2000-1 Addison Circle

Roundabout Design & Operational Review (Lee  
Engineering) - 2005

**ADDISON CIRCLE  
DESIGN, OPERATIONS, AND SAFETY REVIEW**

July 2003

**FIGURE 3:  
Pedestrian Crossing Locations**

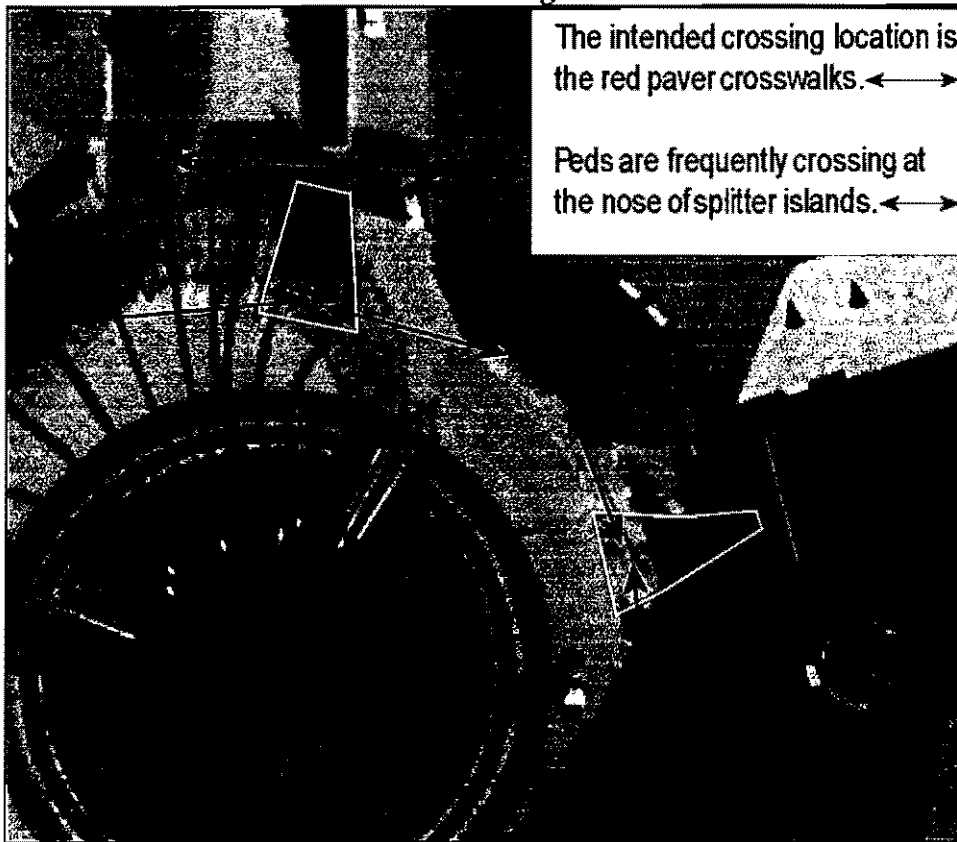
Pedestrians were frequently observed crossing outside the crosswalks, particularly at the nose of splitter islands. Pedestrians were apt to take the fastest path through the area, which often led them to cross at the nose of splitter islands and walk along the sidewalk adjacent to the roundabout (*Figure 3*). This presents a possible safety issue, as the large red paving stone crosswalks lead the motorist to expect people to cross further back from the roundabout itself. No signage, landscaping, bollards or other channelizing objects direct pedestrians towards the crosswalks.

**FIGURE 4:  
Pavement Markings Faded and Worn**

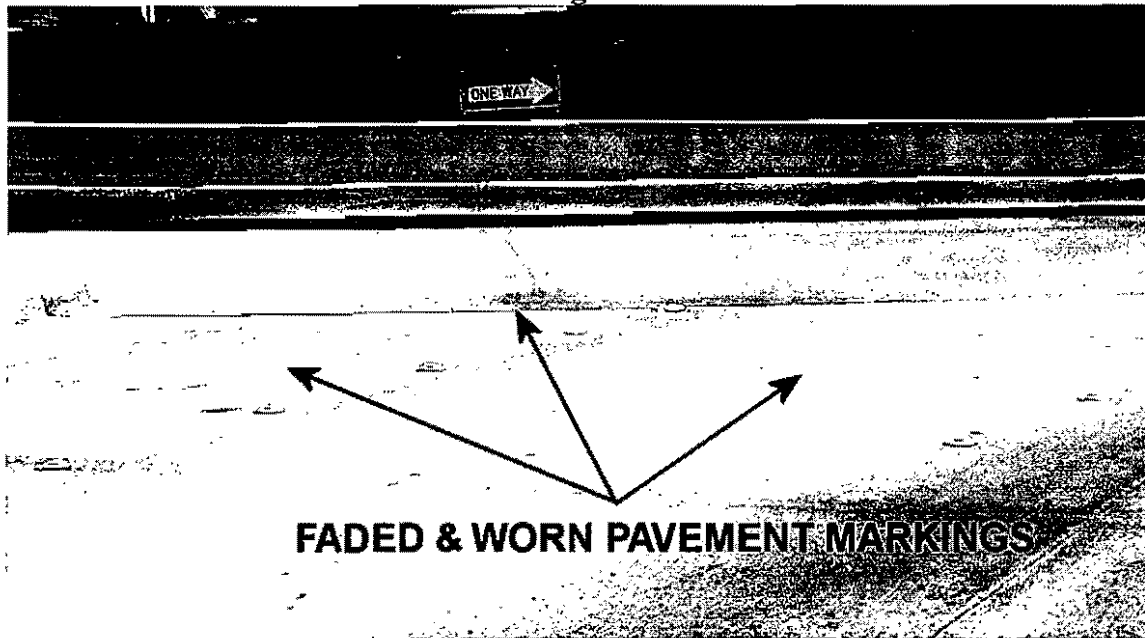
- Pavement markings at the entries are faded and worn, and visibility of these markings is significantly reduced from their original form (*Figure 4*);

- Remove all faded/worn word markings “YIELD” from the pavement on the northbound and southbound approaches as they indicate a three-lane approach. Install new “YIELD” word markings that reflect the striping for a two-lane entry.

- Replace worn “YIELD” markings on the eastbound and westbound entries.
- Broken white line inscribed circle markings should be reinstalled as shown in *Figure 18* as they provide a visual cue as to the edge of the circulatory roadway.

**FIGURE 5:  
Obscured Yield Ahead Signs, Northbound**

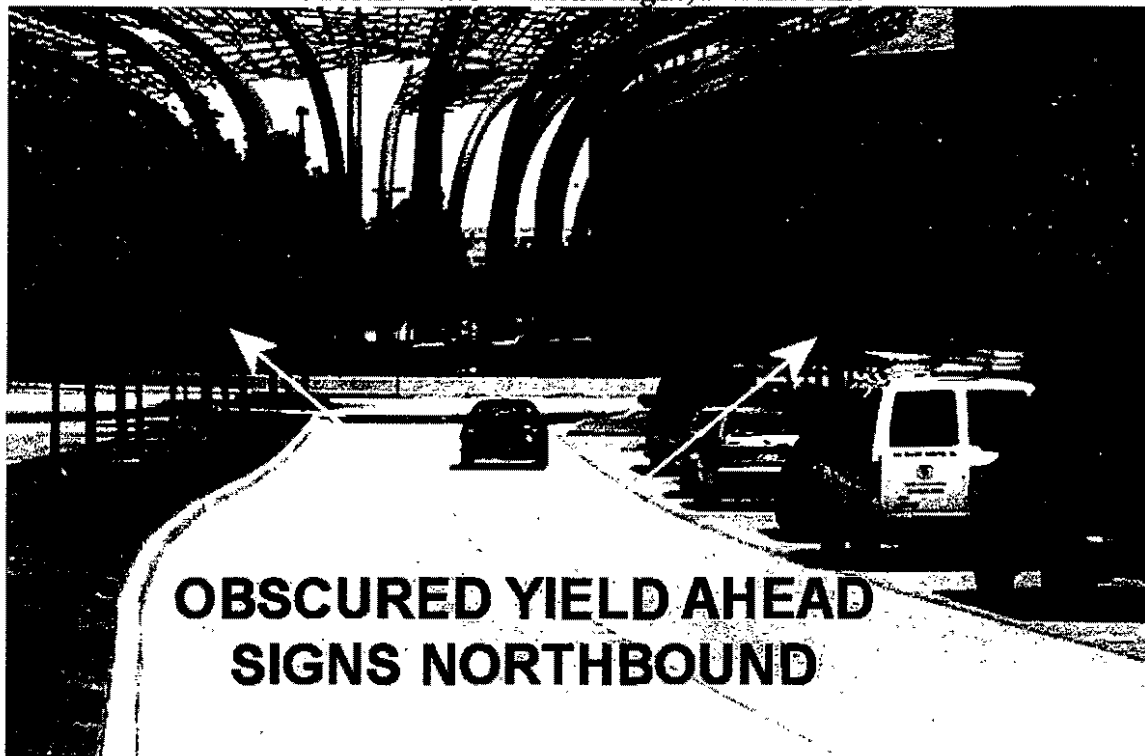
- Both yield ahead warning signs on the northbound approach and one yield-ahead sign on the southbound approach are obscured by trees. The second yield-ahead sign on the southbound approach will be obscured by uncut tree growth in the coming months (*Figure 5 & Figure 6*);

- Relocate yield-ahead signs so that they are in front of trees that currently obscure them or actively trim all tree growth that currently obscures or threatens to obscure existing signage.
- Trim excessive tree growth that currently obscures westbound yield sign and southbound guide sign.
- Remove the four one-way signs currently present on the center island, leaving the chevron warning signs in place.

**FIGURE 7:  
Obscured Guide Sign, Southbound**

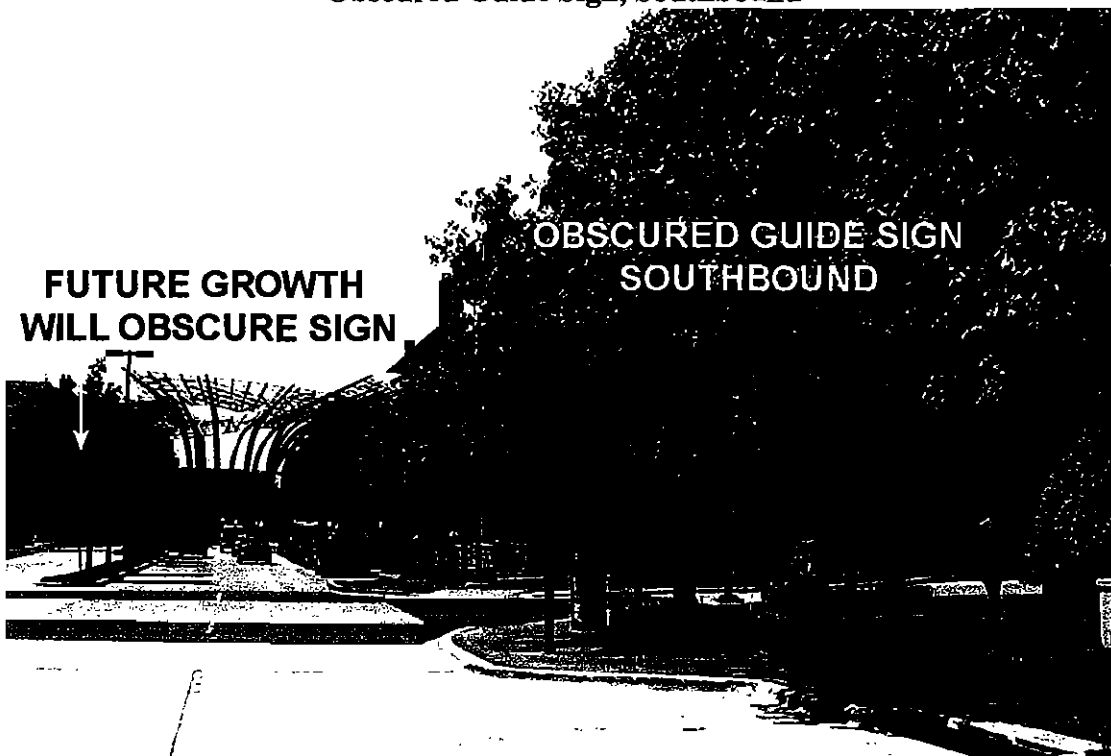
- The large green roundabout guide sign on the southbound approach is partially obscured by trees (*Figure 7*);
- The large green roundabout guide signs provide no lane use instructions to motorists approaching the roundabout;

**FIGURE 8:  
Westbound Obscured Yield Sign**

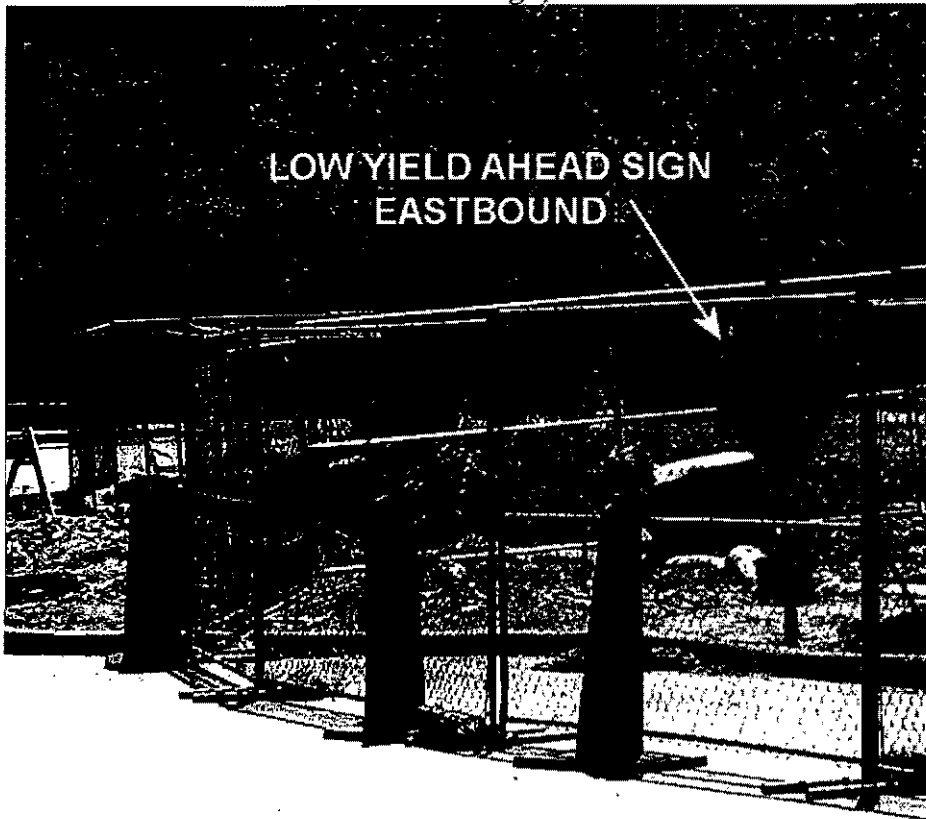
- A yield sign on the westbound approach is obscured by tree growth (*Figure 8*);
- No crosswalk warning signs are present to alert drivers to the crosswalks;
